**From:** Dennis Bechis <dennisbechis10@gmail.com>  
**Sent:** Monday, July 18, 2022 3:35 PM  
**To:** Eric Bernstein; rosie03033@yahoo.com; Michele Decoteau; michelebdecoteau@gmail.com  
**Cc:** Eric Pauer  
**Subject:** Letter to PB on Rough analysis of earth moving in Brookline center  
**Attachments:** cid4C430EEB-1F39-43AF-A704-D03B9AD06784.pdf; Brookline\_Town\_Center\_Project\_4.pdf.pdf

I examined and did a rough analysis of the Meridian Land Services drawings for the proposed development. Unless I am mistaken, the graphic scale presented in the lower right corner of the 8.5"x15" drawings is in error. The scale should be 1 : 80 (IN:FT), not 1:40.

Calculation of drops in elevation PRE- and POST construction at X-intervals of 80 feet along Y-slices separated by 80 feet (see penciled grid on Meridian Land Services grading plan) (Note: Main Street lies near X=10; y=0,1, and=7 slices not used) (Note: one inch on 11"x15" map = 80 feet on land)

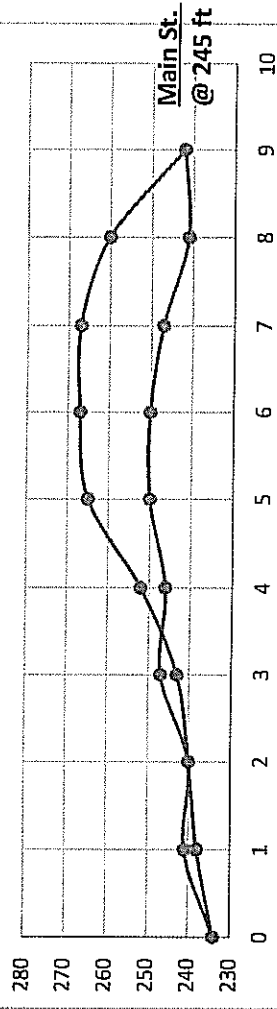
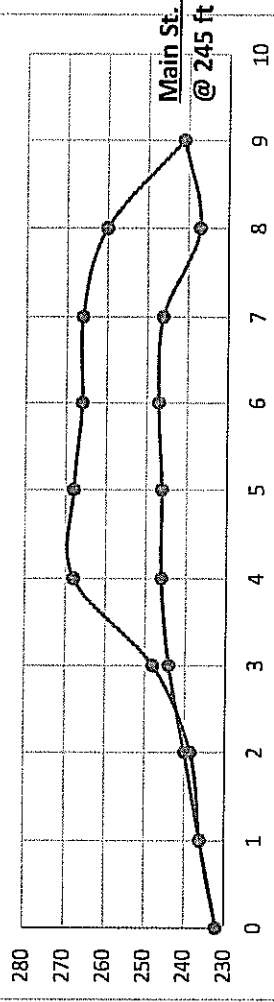
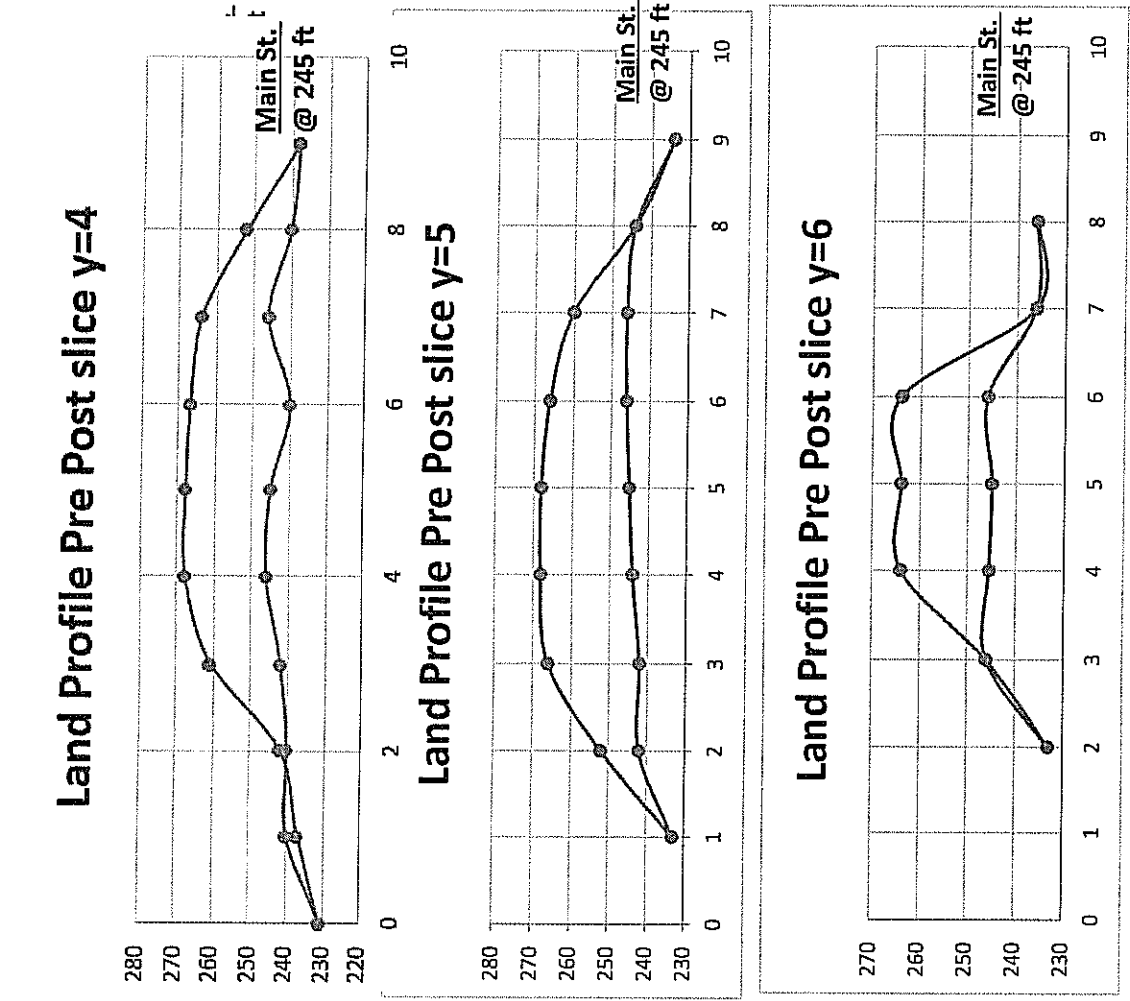
By slicing the lot at 80 foot separations (horizontal lines in 1st attachment) and noting the depth of soil to be removed at regular intervals of 80 feet (vertical lines) and by plotting the results, one can visualize the contours of soil that will need to be removed. In the 2nd attachment, the blue curves show the present topography of the land (peak at 268') along the horizontal slices while the red curves show the proposed elevation (245' ) of the building site after removal of soil and boulders. The 245' elevation matches that of Main Street near Sargent Road. From this analysis, one can estimate the volume of soil/boulders to be removed at 3 million cubic feet. Assuming a dump truck capacity of 270 cubic feet, this corresponds to 11,000 dump truck trips

At the next PB meeting where the development is discussed, I would hope we can hear how the development would be conducted with acceptable impact to Brookline's roads and the traffic near Sargent Road and Main Street. The volume to be removed - which will permanently change the topological profile of Brookline - is also of concern for potential impacts to the underlying aquifer and to the Nissitissit Wild and Scenic River.
